Technical Notice

2021-11-08

After cMT3161X / cMT3162X runs for an extended period of time, there is a chance for the LCD screen to exhibit signs of flickering and color anomaly. Should this happen, please follow the guidelines in this notice to fix the problem.

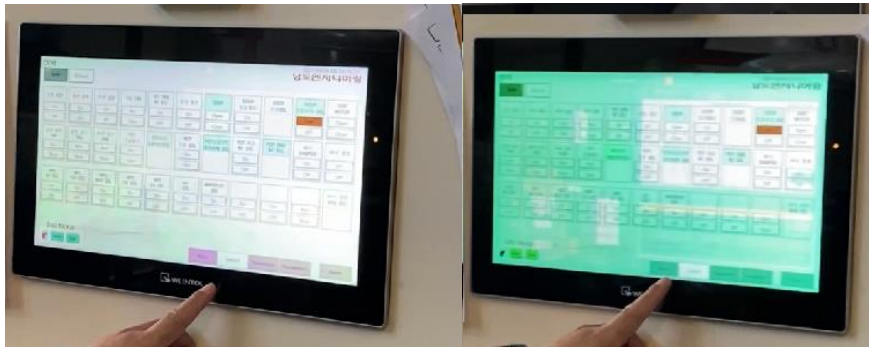
Normal

Color anomaly

First, obtain the date of production as indicated by the first four digits of the serial number. For example, serial number S/N:2102xxxxxx means the date of production is February 2021. Knowing the date of production, take the corresponding suggested action.

Date of Production	Suggested Action
After 2021/03	If the problem persists after ruling out interferences, send the machine back for service and inspection.
Before 2021/02	Update LCD firmware.

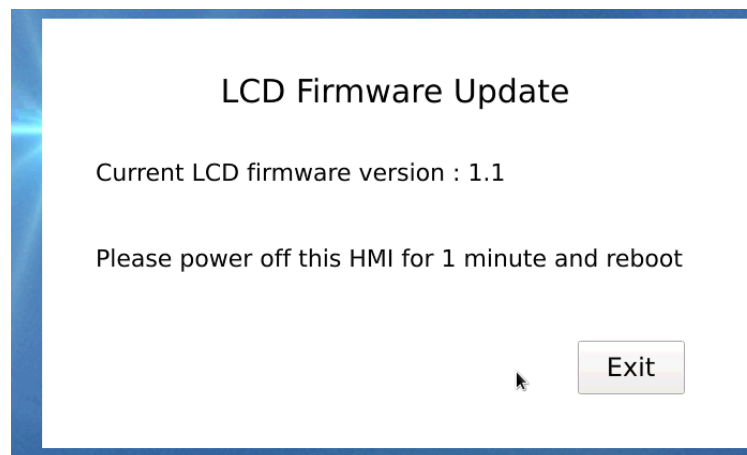
1. Decompress the “cMT-X-20211105-lcd-update-fw.zip” file to obtain the “MTfirmware.bin” file, and then update OS normally using this file. ([OS Update Instructions](#))
2. After updating the OS and rebooting HMI, the screen should display information about LCD Firmware Update. As shown below, the current LCD firmware version is 1.0 and the latest LCD firmware version is 1.1. When the latest version number is greater than the current version number, please click [**Update**] to update LCD firmware.

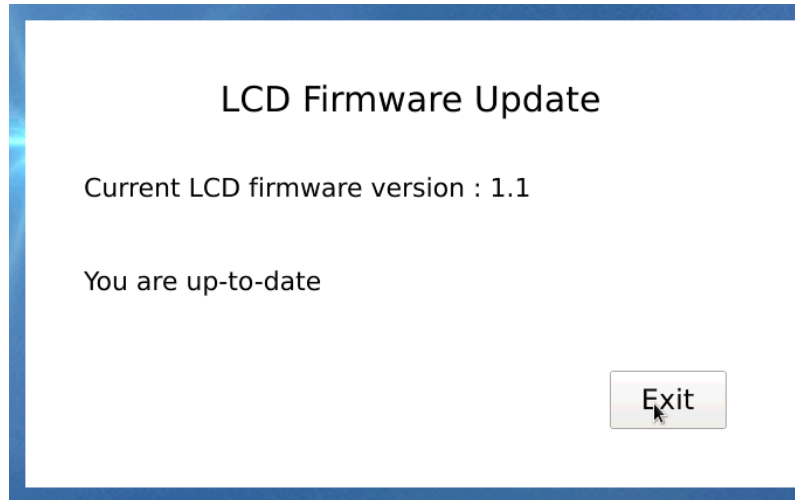
The following screen is shown after update. **Please follow the onscreen guideline: i.e., power off the HMI and then let it rest for at least one minute before powering it on again.**

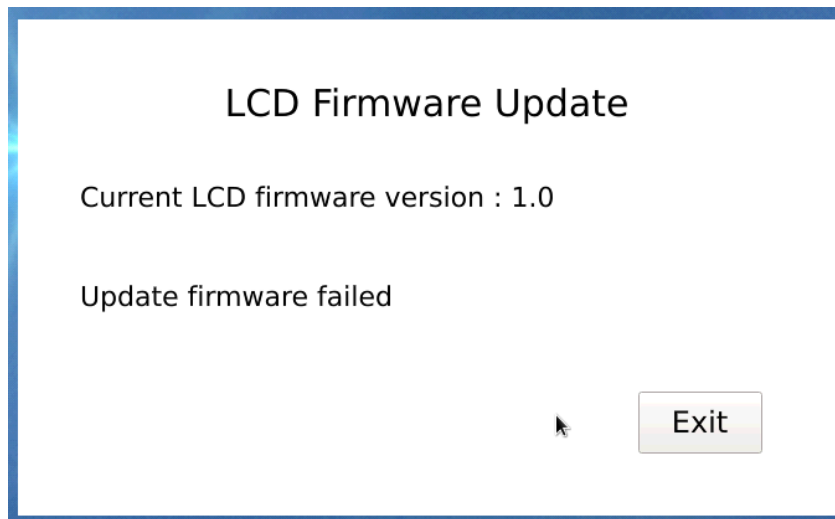
After rebooting the HMI, the window below should appear, showing that the current LCD firmware version is 1.1.
